## **MOORE SUBDIVISION**

Engineering Comments: FINAL PLAT COMMENTS (should be addressed prior to submitting the FINAL PLAT for review and/or signature by the City Engineer):

***Revised for the May 20<sup>th</sup> meeting:***

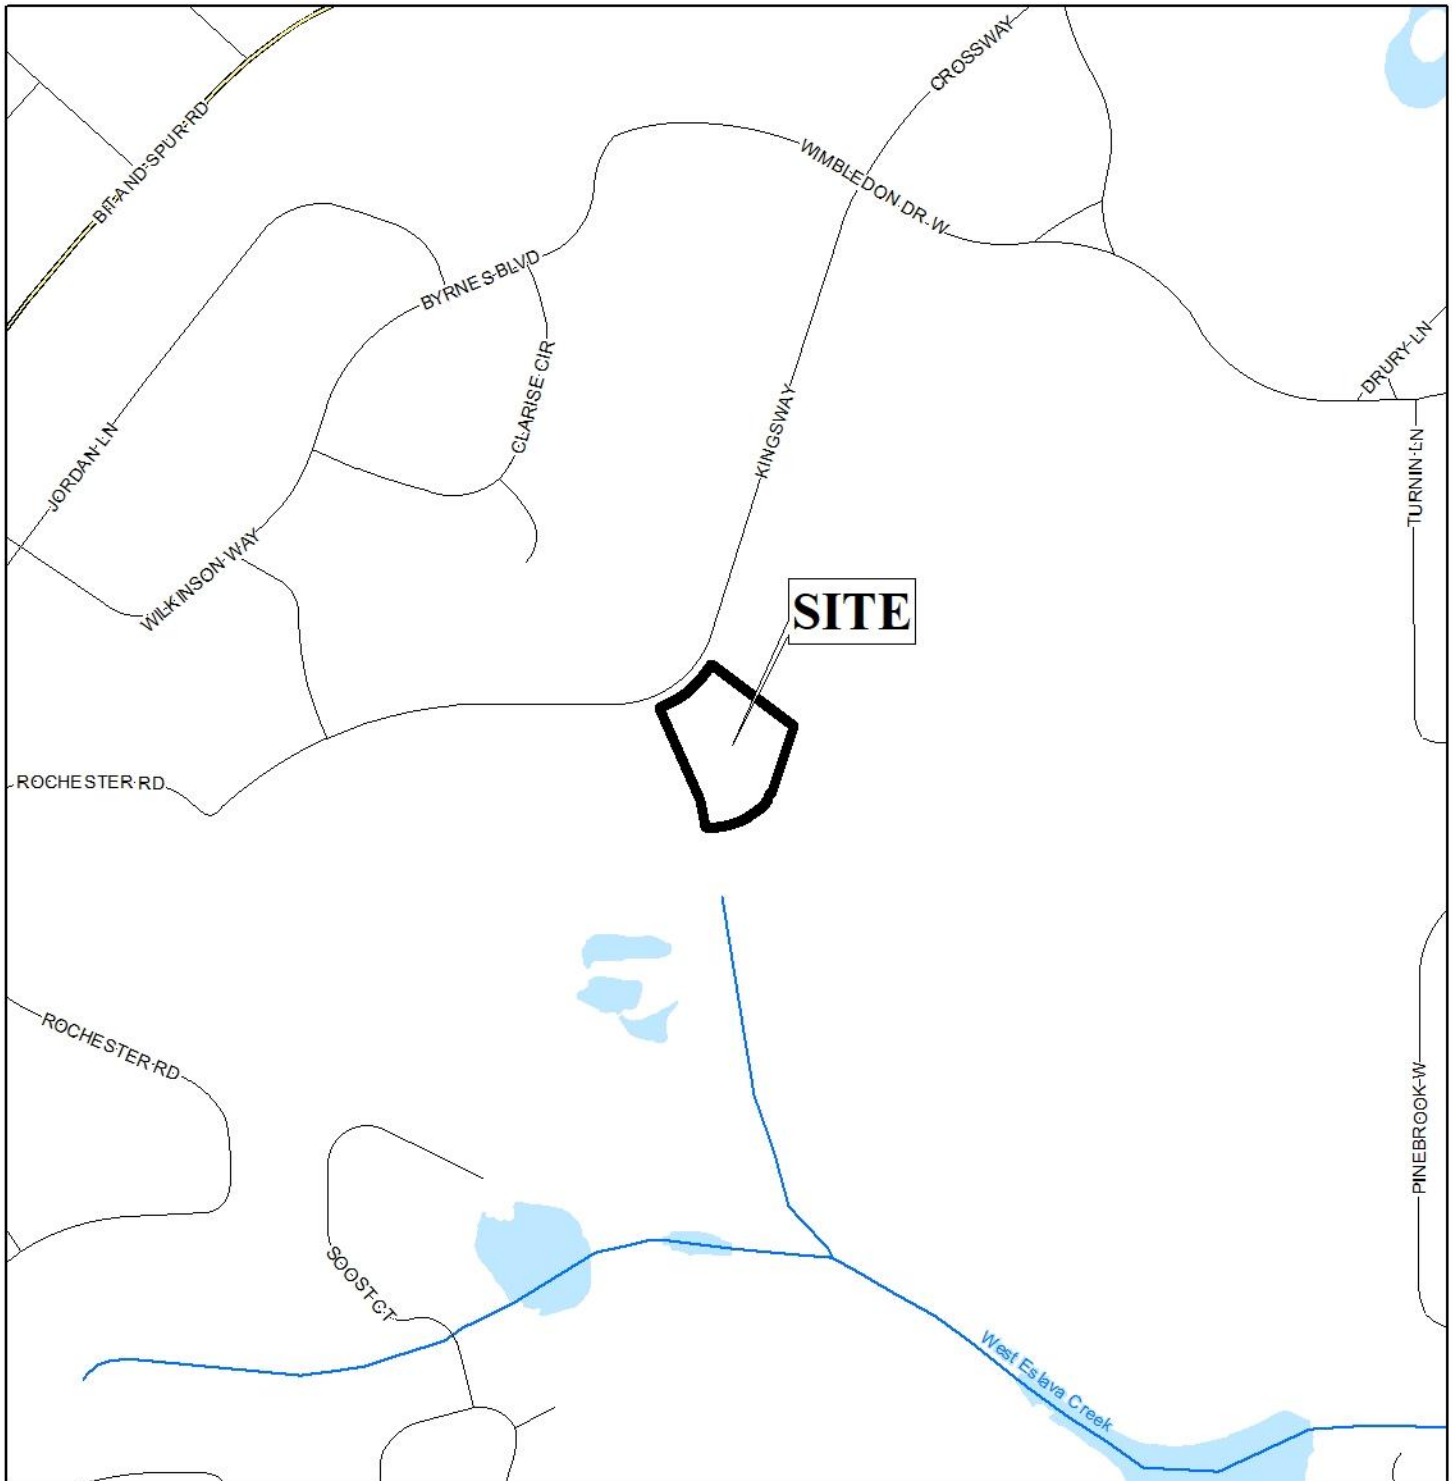
*We have worked to revise the plat following the meeting yesterday and will be asking for several waivers. I have provided an attachment that shows other irregularities within the area. You can see that there are 8 flagged lots (orange highlighted) within the vicinity of this property which the City has always taken issue with in the past. Our property does not reflect a flagged lot scenario but actually is more of a cul-de-sac approach due to the close to 90 degree curvature of the road to the north. This configuration that exists limits the amount of frontage available in comparison to a traditional lot on a straight run. What it also provides is a much larger footprint on the rear of the property view along the golf course in which all three proposed lots exceed well over 110 feet each. The prime real estate in our opinion is at this location as it is similar to waterfront property in that your pristine view is to Mobile Country Club and provides adequate room to build homes (see lot dimensions).*

*We would like to also point out several lots that appear to not meet the length to width ratio we are being asked to request as a waiver (noted in Green on the tax map). Specifically they have an alternative approach in which the rear of the properties is much less than the 100 foot frontage (some sub 60 feet to just shy of 70 feet) \*\*see Saunders Addition just west of our proposed subdivision\*\*. We believe that if a waiver should be required that this should provide justification to waive the length to width ratio in conjunction with the flag lots or irregular lots in the vicinity.*

*The applicant brings up several existing lots in “the area” that are flag lots or exceed the width-to-depth ratio. While there are flag lots in the area that have been approved by the Planning Commission, in terms of driving distance, these lots are over ¼ mile away.*

*The applicant points to five (5) lots in the area (green) which exceed the width-to-depth ratio, however, it is important to note that Section V.D.3. of the Subdivision Regulations specifically states that “the maximum depth of any lots shall not be more than 3.5 times the width of the lot at the building setback line”. If the lots referenced by the applicant are looked at with this definition in mind, four of the five “green lots” comply with of the Subdivision Regulations.*
